County of
INYO

Re: Hidden Hills Solar Energy Generating System, Application for Certification (11-AFC-2)
Access and Circulation Issues

Plans Prepared by: INYO COUNTY PUBLIC WORKS 168 N. Edward, P.O. Drawer Q Independence, CA 93526 (760) 878-0201		OLD SPANISH TRAIL HIDDEN HILLS SOLAR RIGHT-OF-WAY WIDENING	
		Date: 05/07/12	EXHIBIT 1
Designed by: D. WILSON	Drawn by: J. EROPKIN	Drawing Name: OST-WIDENING.DWG	SHEET 1 OF 1

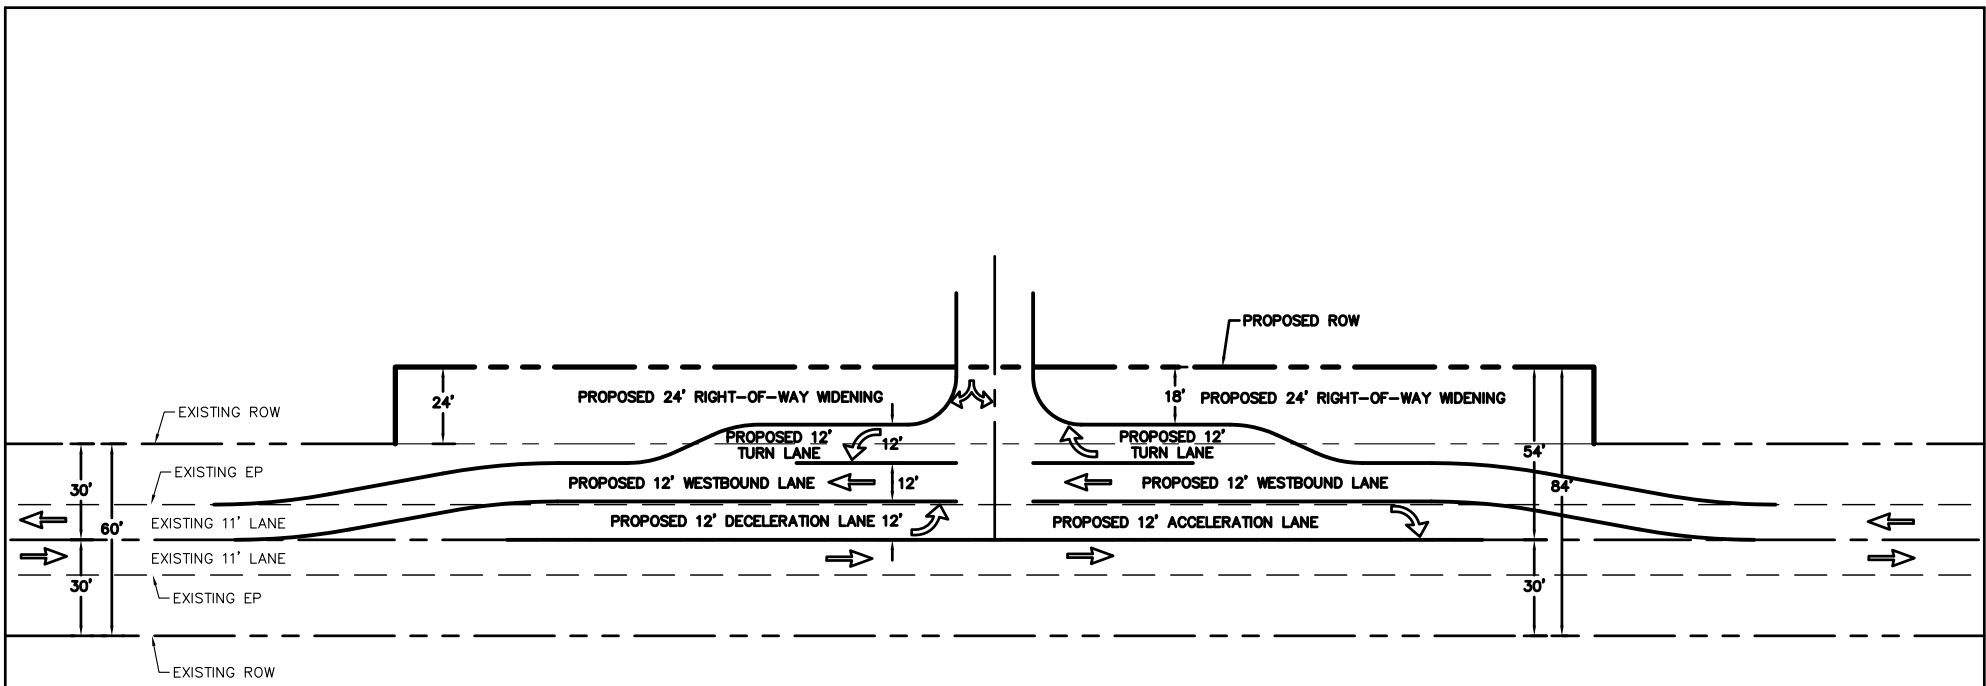
TURN LANES: Due to the potential speed differential and resulting conflicts for vehicles (including trucks) turning into and out of the project site to and from the east, turn pockets should be provided to accommodate the slower truck traffic that can be expected during both the long-term and the short-term. Based upon Table 5-12.7 currently, truck traffic to and from the west is not expected; however if truck traffic is expected from the west, then turn lanes into and out of the site at each access point should be considered. We suggest that the turn pockets be a minimum length of two of the maximum truck lengths to be entering the site. Turn lanes include acceleration lanes for trucks exiting the site. The lanes should include transitions for adding and dropping lanes.

RIGHT-OF-WAY DEDICATION: We suggest that right-of-way be dedicated along the project frontage to accommodate turn lanes and potential future widening of Old Spanish Trail. . We suggest that 12 feet be dedicated for each of the lanes mentioned for these purposes (24 feet where there would be a left turn lane and an acceleration/deceleration lane). We anticipate this will result in an additional right of way with a minimum width of 24 feet across the frontage on the property.
